## ADDENDUM NUMBER 2

Project Number **CMAQ 3319(412), City Project 70171305**

Project Title **I-35 and Chouteau Parkway  
Interchange Improvements**

ISSUE DATE: **11/12/2020**

ROADWAY DETAILS  
SHEET NUMBER

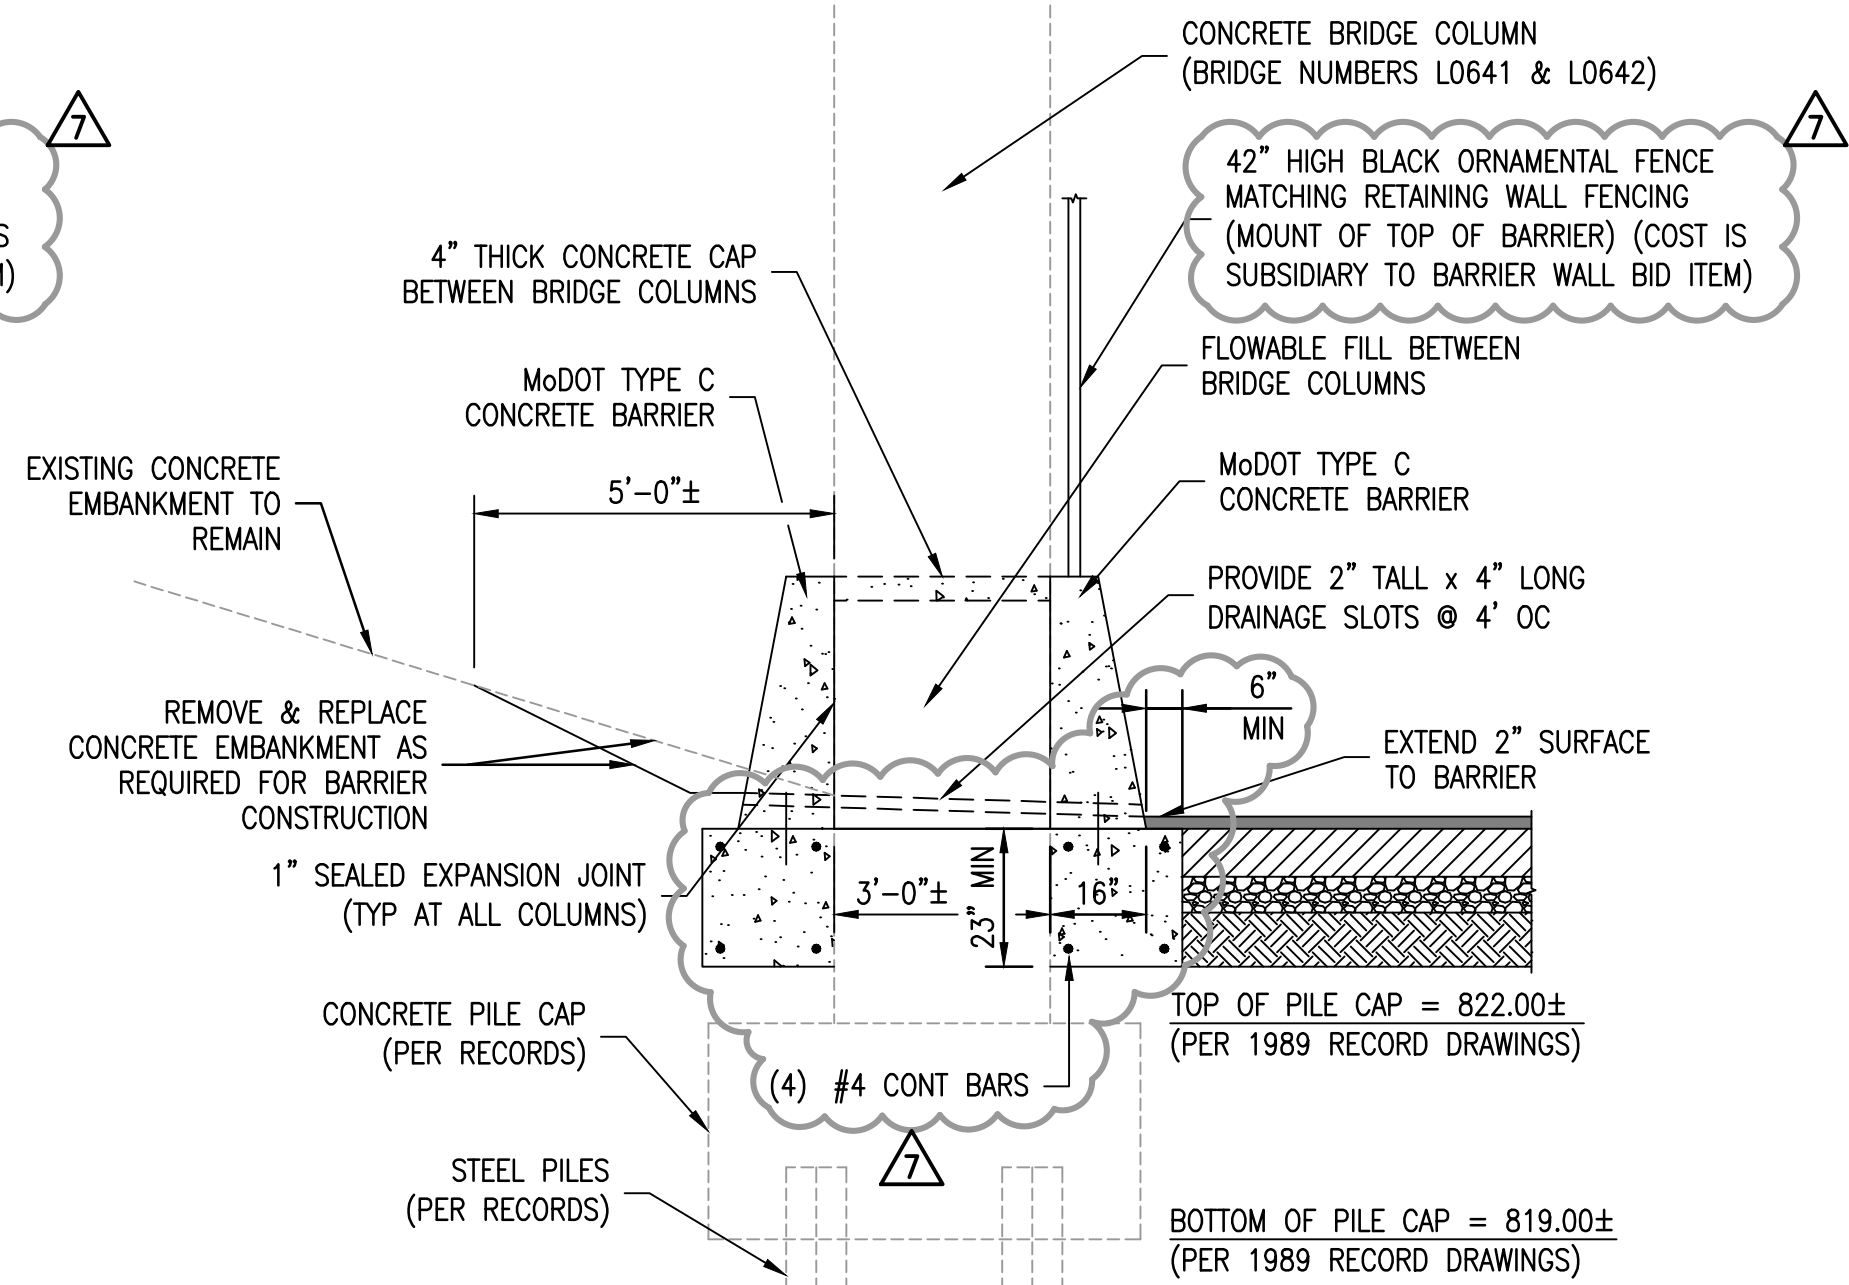
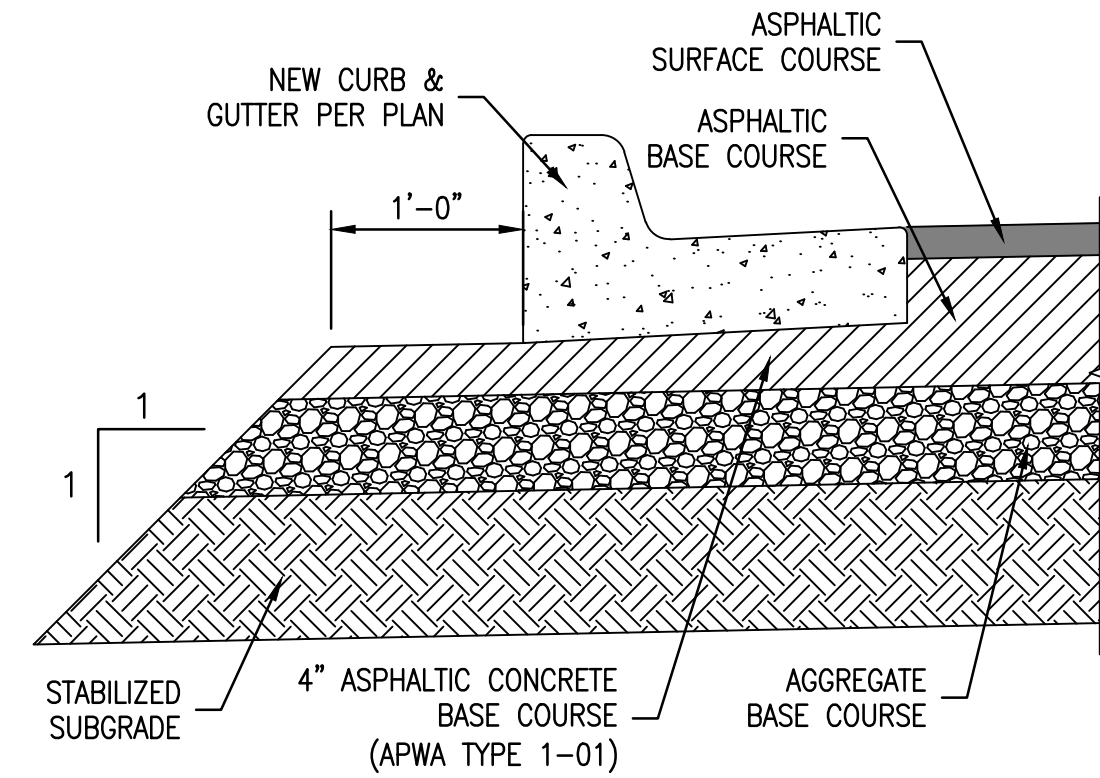
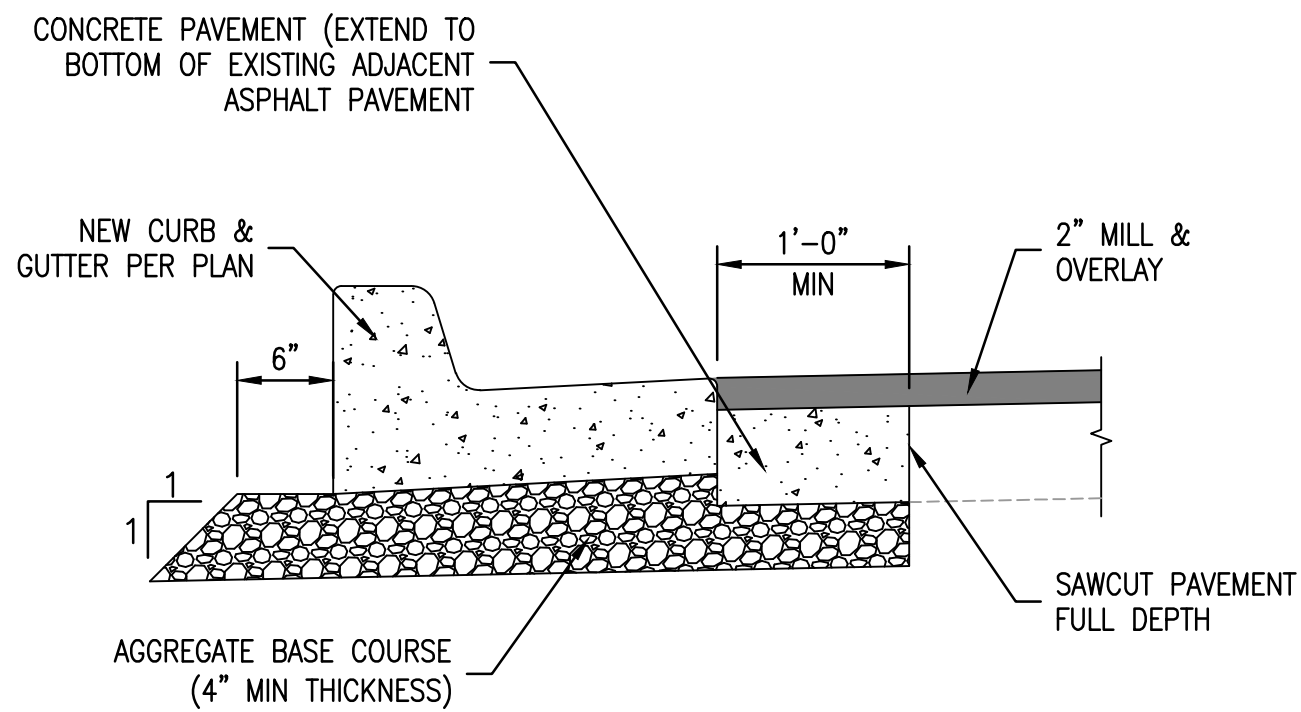
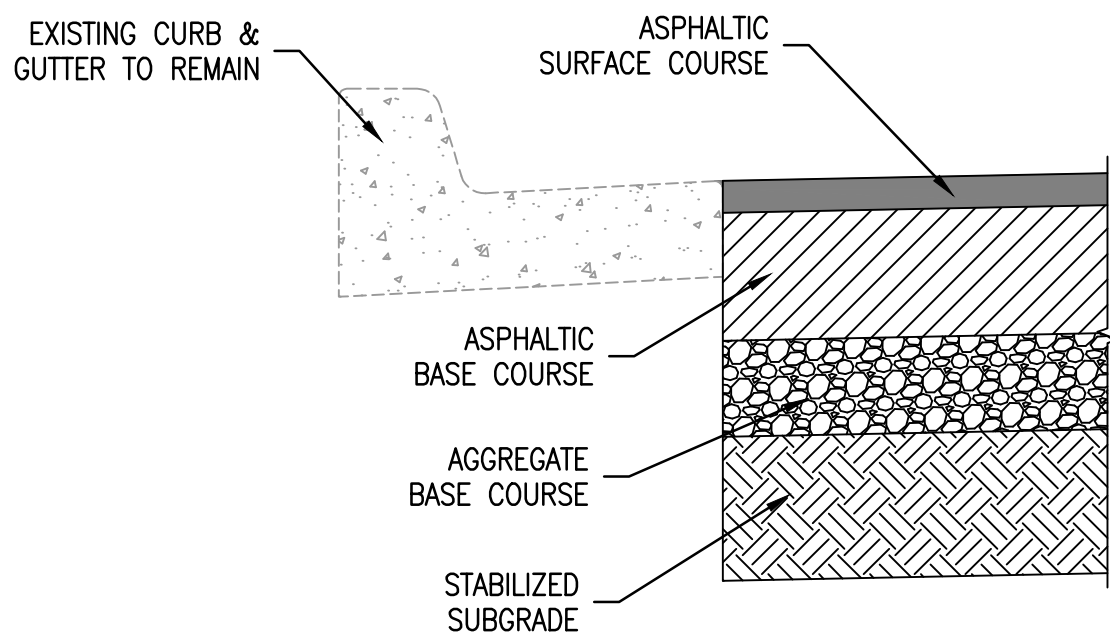
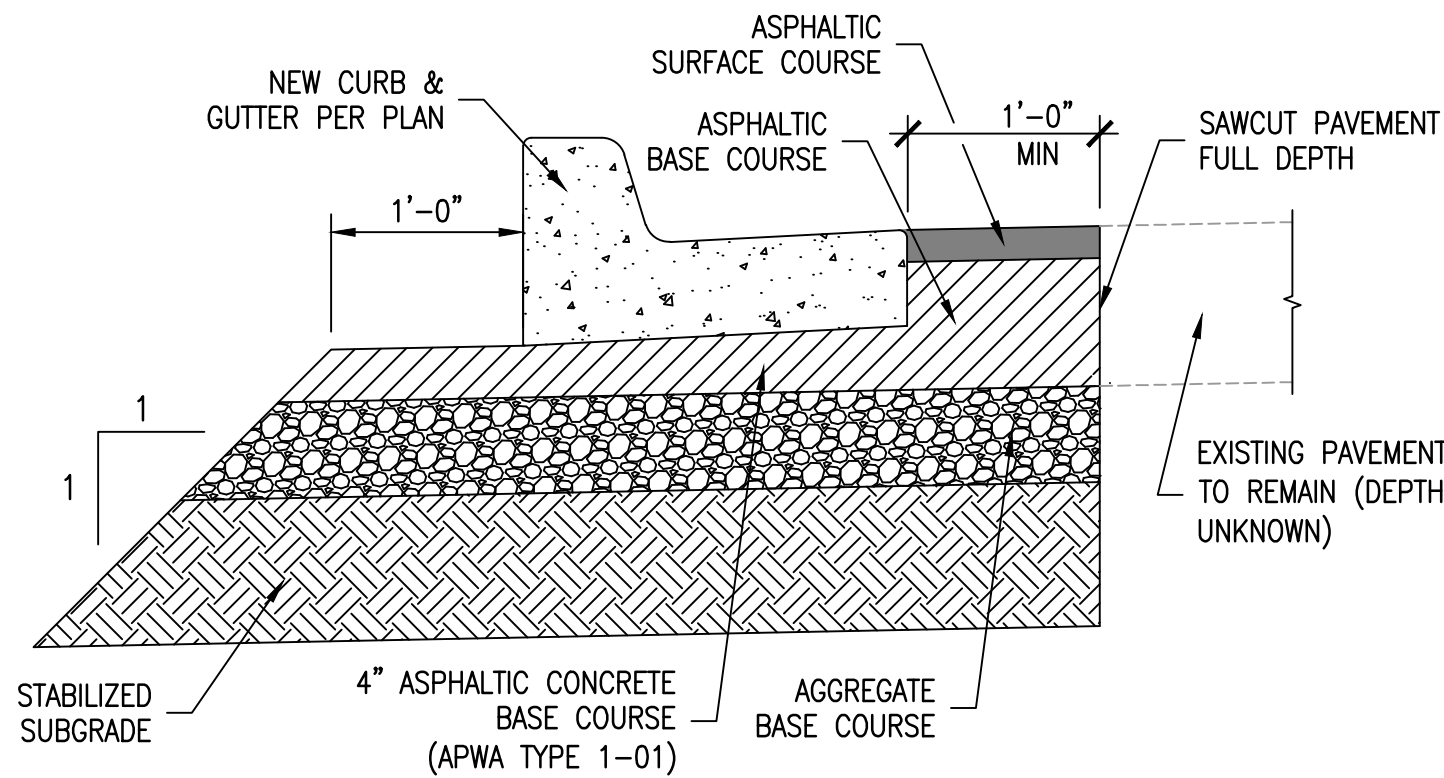
<b>A7.</b>	<b>Reinforcing details and requirements are shown on MoDOT drawing 617.10M (sheet 3 of 11).</b>
Q8.	Plan sheet 21 of 102 note 3 of the retaining wall calls out a fence on top of the wall. Is this correct?
<b>A8.</b>	<b>Fencing is required on top of retaining walls. Fencing is subsidiary to the Large Block Retaining Wall bid item.</b>
Q9.	Plan sheet 36 of 102 shows a fence on top of the concrete barrier. Is this correct, and if so what type of fence and how is it paid for?
<b>A9.</b>	<b>Fencing is required on top of concrete barrier wall as shown on detail 1 and detail 2 on sheet 36. Additional fencing information has been added to these details. Refer to attached revised section 02308 Fencing. The intent of the fencing is to match existing fencing located along the south side of Chouteau Parkway east of NE Parvin Road.</b>
Q10.	The quantity of Type 2 Rock Blanket appears to be in error based on our takeoff. We are coming up with a much smaller quantity.

<b>A11.</b>	<b>The quantity of the Type 2 Rock Blanket has been revised on the plans and section 00412 Unit Prices.</b>
